21 August 2019

NL181648vD

Re: Merewether Golf Club Seniors Living - Civil and Structural Preliminary Advice

Development Plans and Layouts Supplied

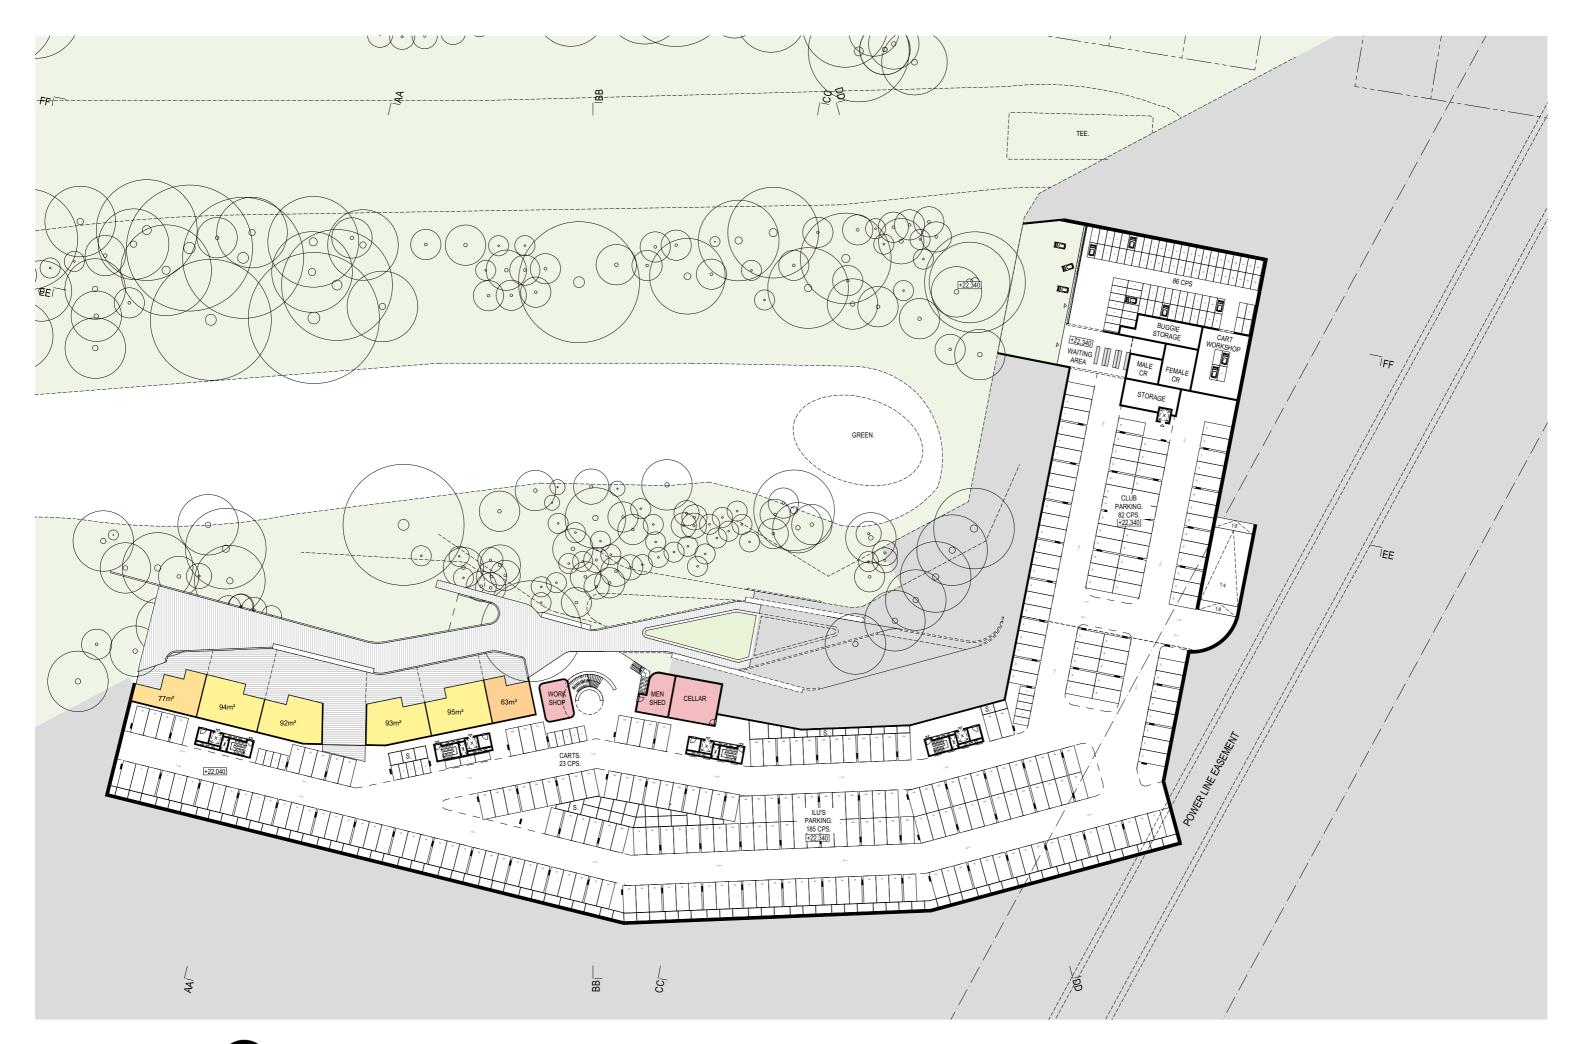
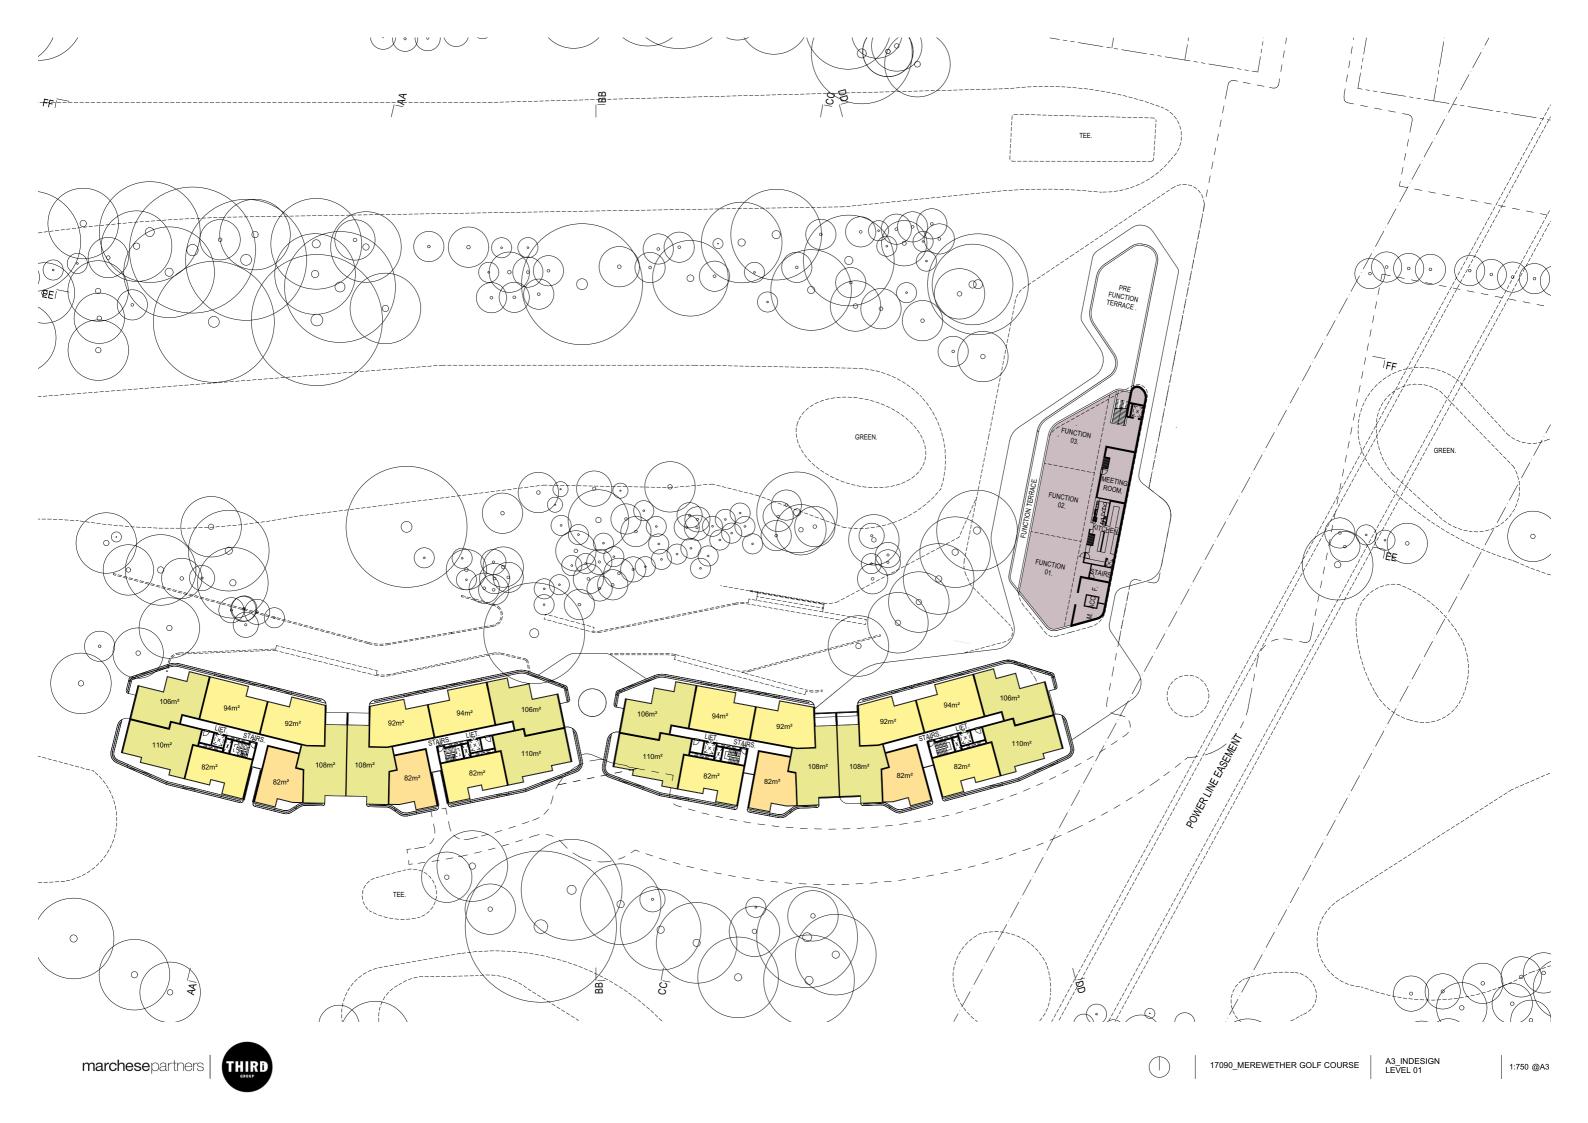
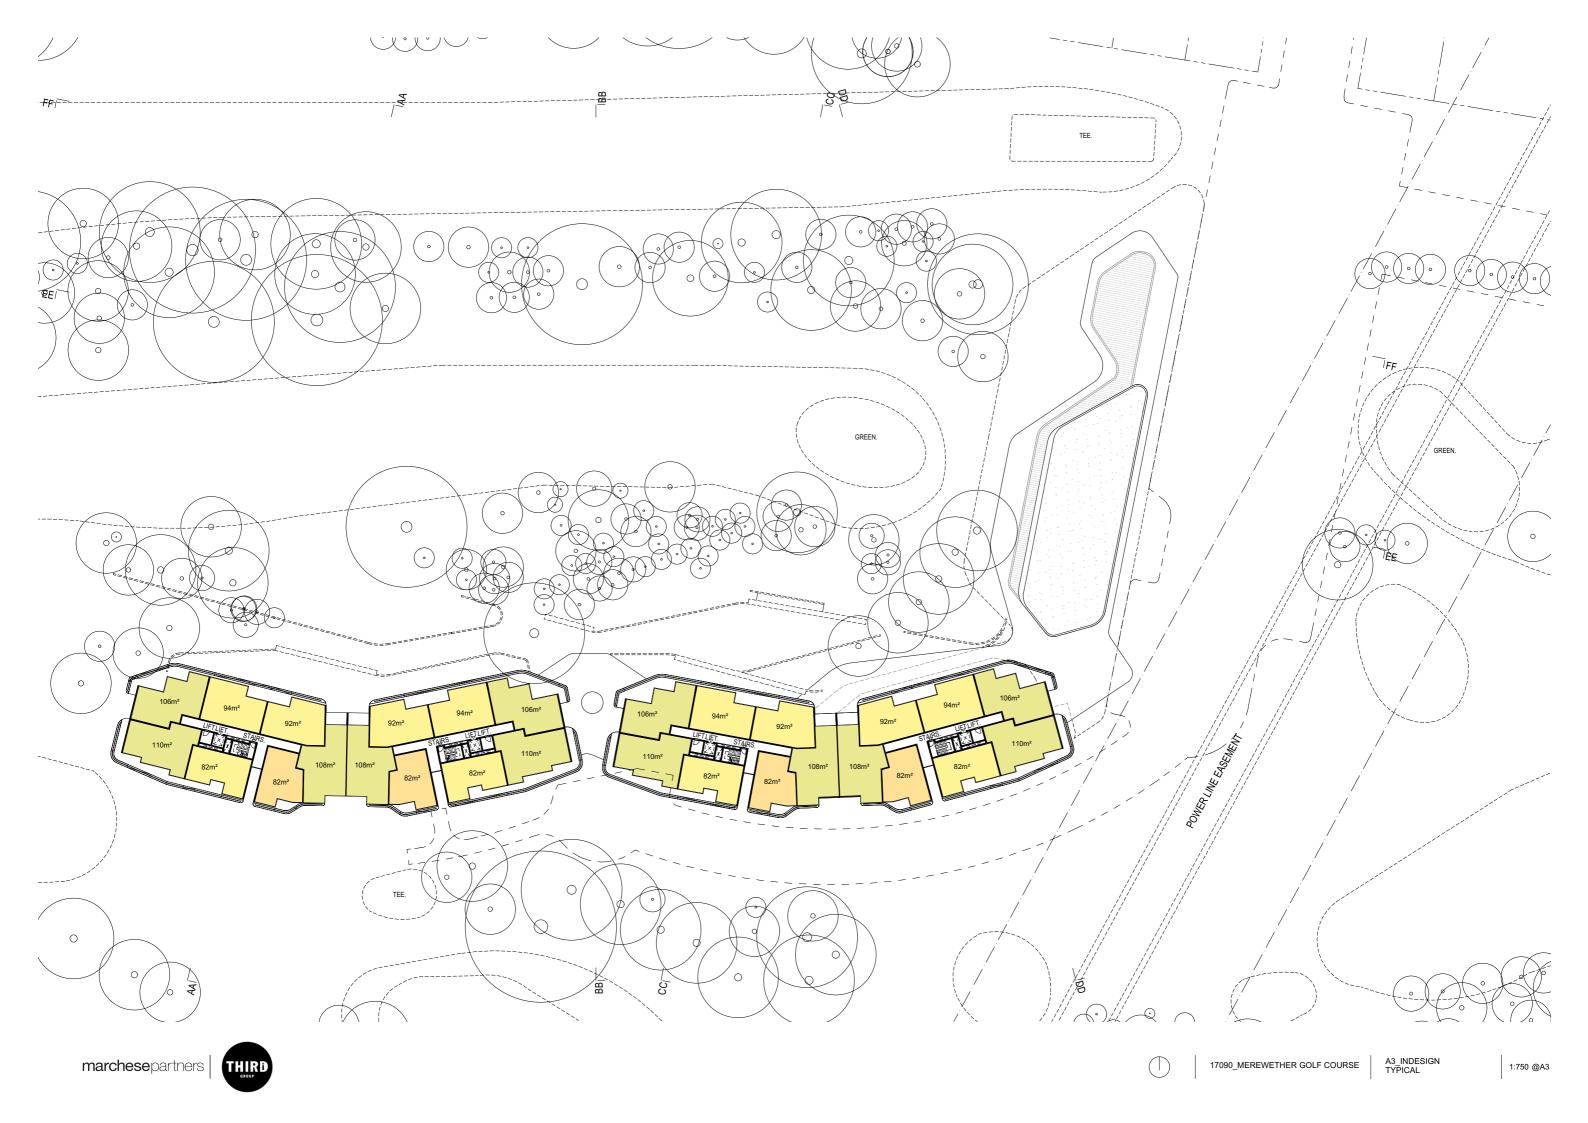
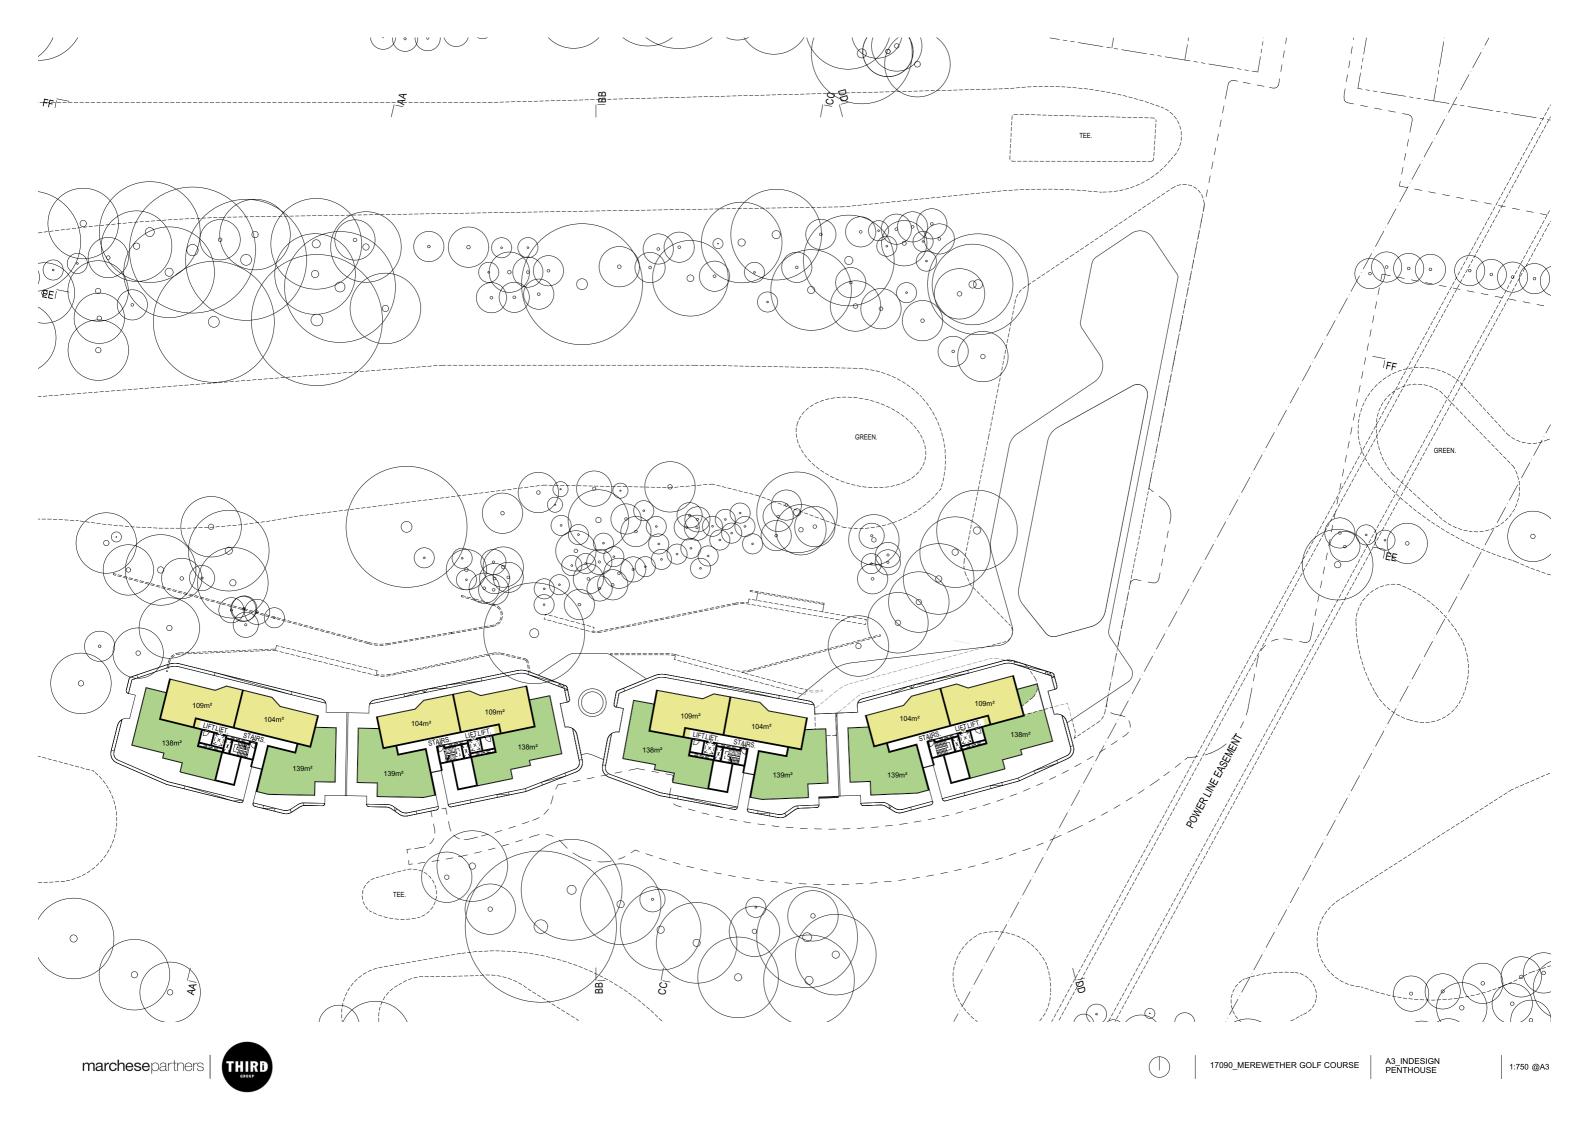
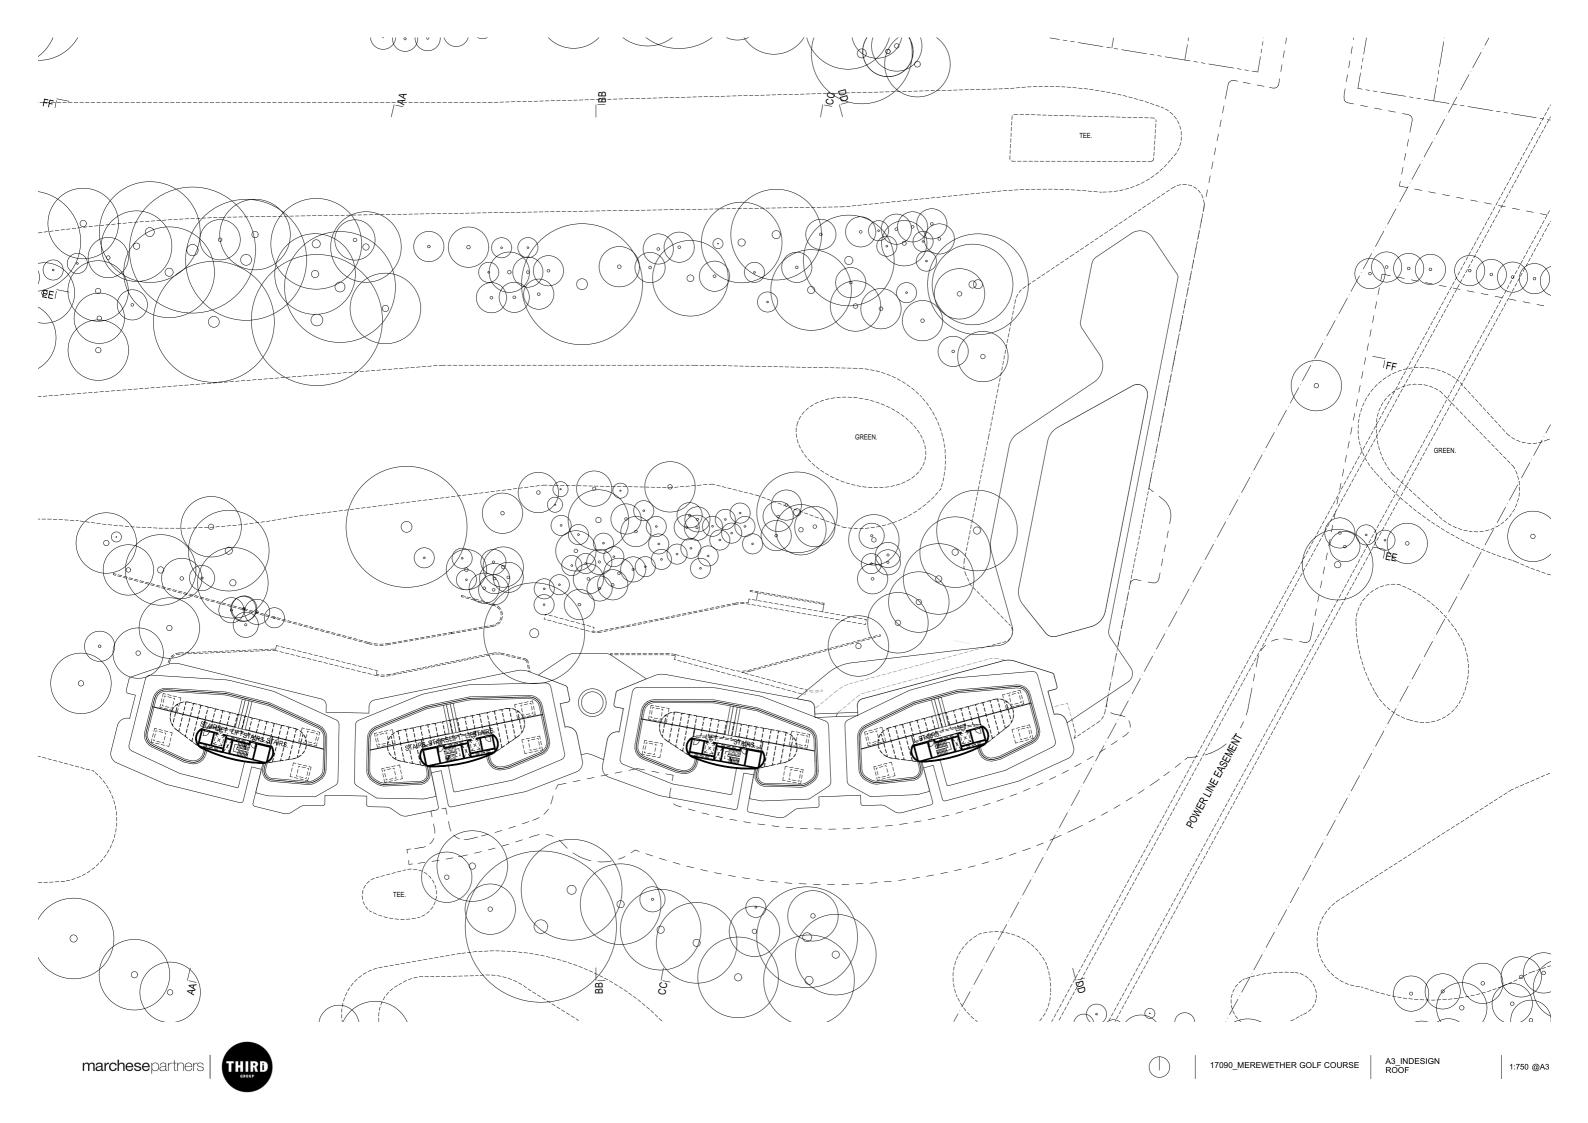
In general, the plans typically comply with many of these design requirements with the exception of fine tuning to improve circulation at the top and bottom of ramps, access ramp grades and radii for larger vehicles and blind aisle turning areas.

Based on our review it is expected that these items can be incorporated at the Development Application phase of the project and should not impact the current footprint of the development.
